**Central Queensland Coal Project
Appendix 10g – 2018 Waterway
Barrier Works Map Amendment
Request**

CQC SEIS, Version 3

Review of waterway barrier works mapping intersecting the Central Queensland Coal Project (ML80187)

Figure B1
 Waterway barrier assessment points
 (north of Bruce Highway) for Styx Project

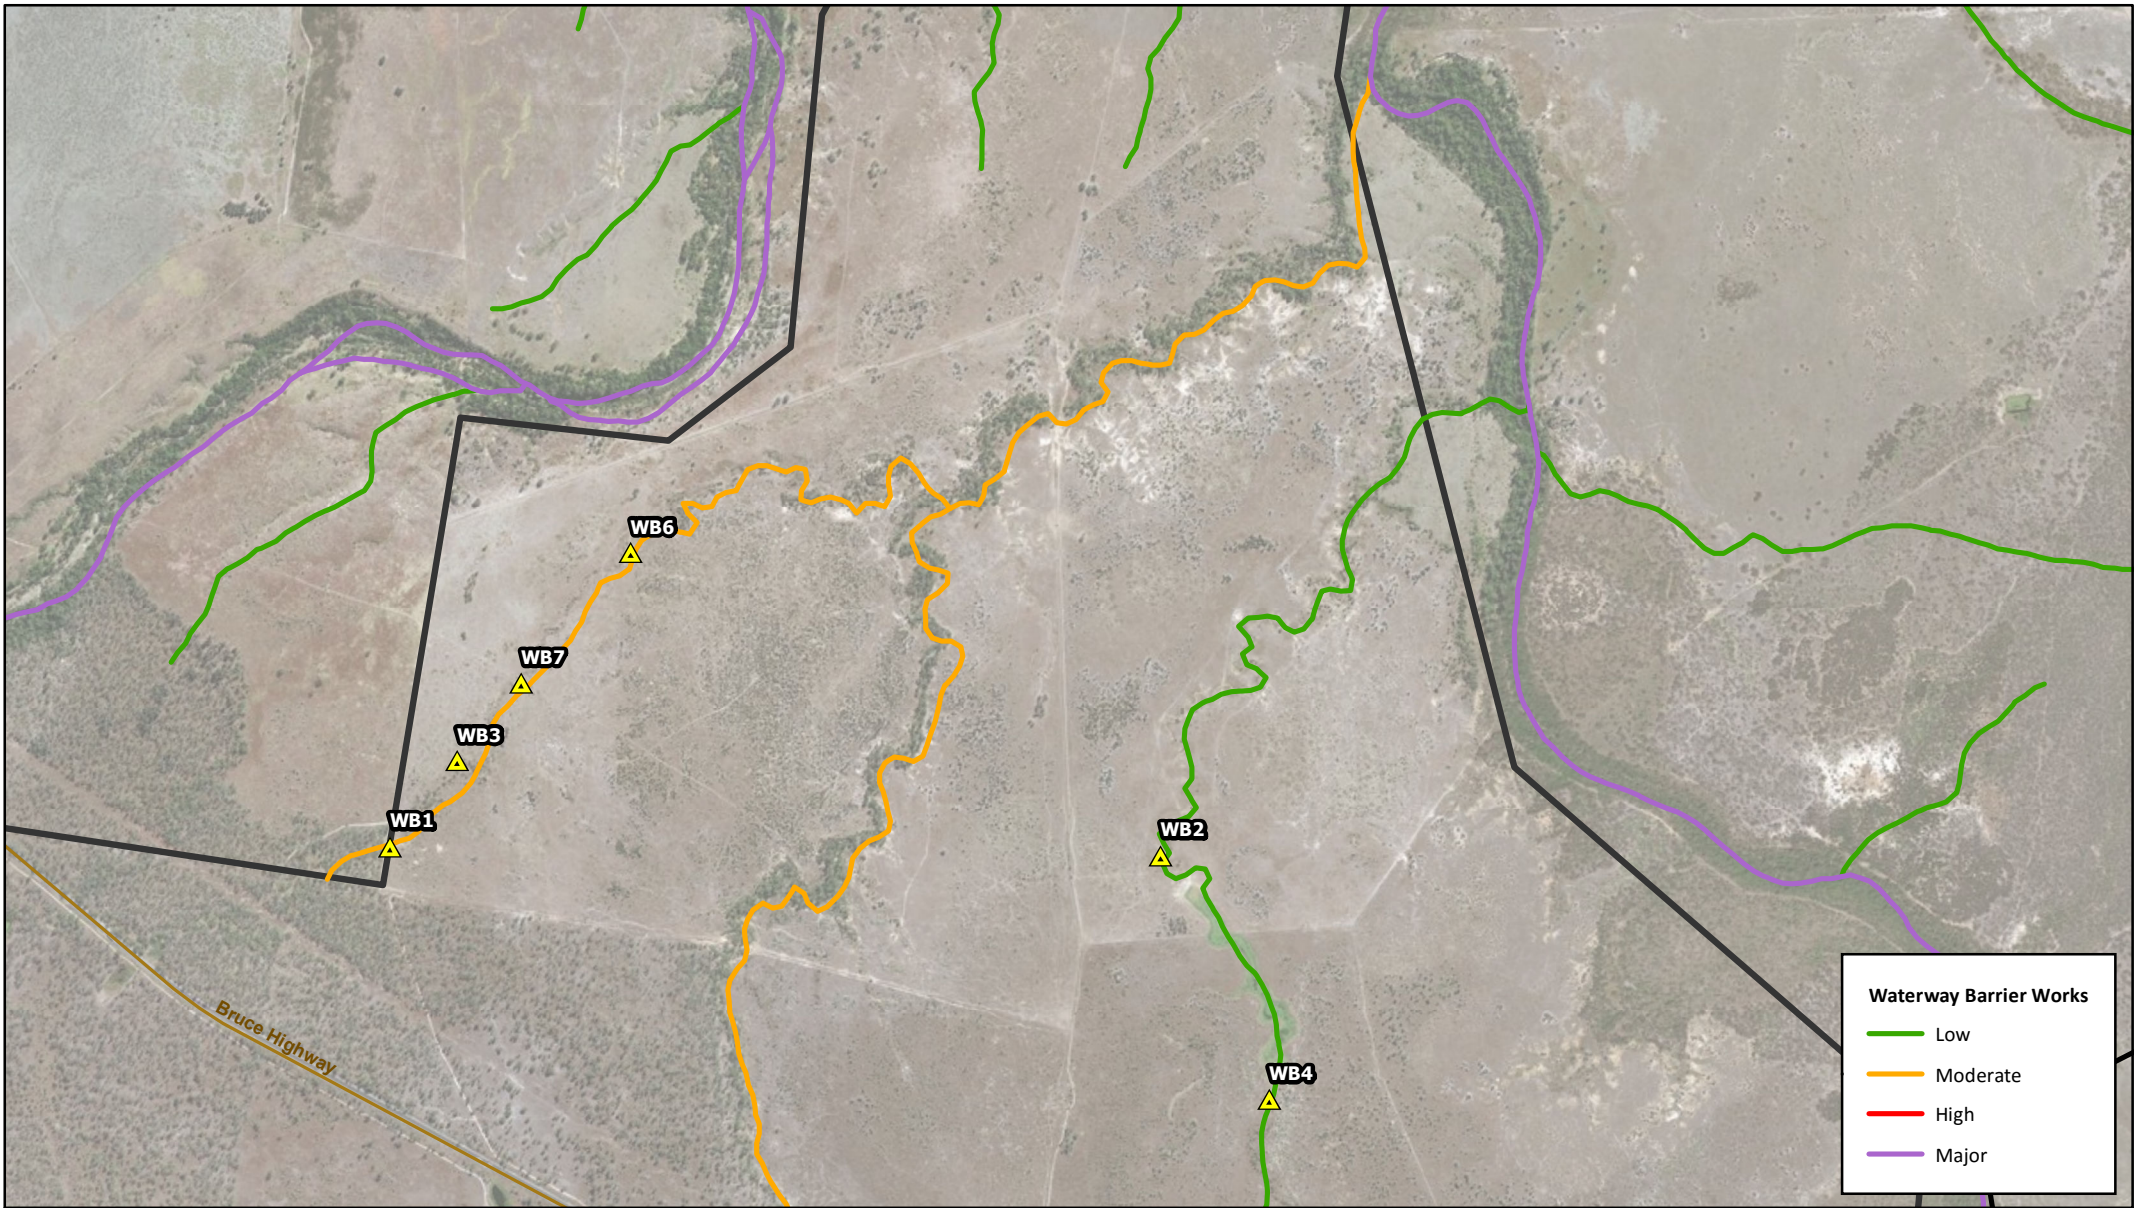
The observations in this attachment pertain to two mapped waterways located to the north of the Bruce Highway (refer Figure A2). It is proposed here that these waterways do not provide habitat for fish.

The following images depict the drainage features of the mapped waterway located in the west of the Mine Lease as indicated on Figure A2 as the survey points labelled WB1, WB3, WB6 and WB7. There is approximately 1 km between survey point WB6 and WB1. The waterway is mapped as a 'moderate risk' (orange) polyline. Site inspection showed the channel is a shallow depression dominated by Buffel Grass and Rubber Vine with some areas of Brigalow regrowth. There is no defined bank at any of these points on the waterway. Photos taken from further south along the same drainage line (from survey point WB7 and further south-west) indicate the channel depression as very slight and almost disappearing at WB1.

The following photos depict two points located upstream and downstream of a dammed depression mapped as a 'low risk' waterway (indicated on Figure A2 as survey points WB2 and WB4). Aerial imagery indicates a low overflow area emanating downstream from the dam. Downstream of the dammed area there is only a shallow 'channel' indicated in the site photos with no formed banks and better described as a depression. Upstream of the dammed area there is no channel and the 'waterway' is limited to a wide landscape depression. Photos taken 31 October 2018.
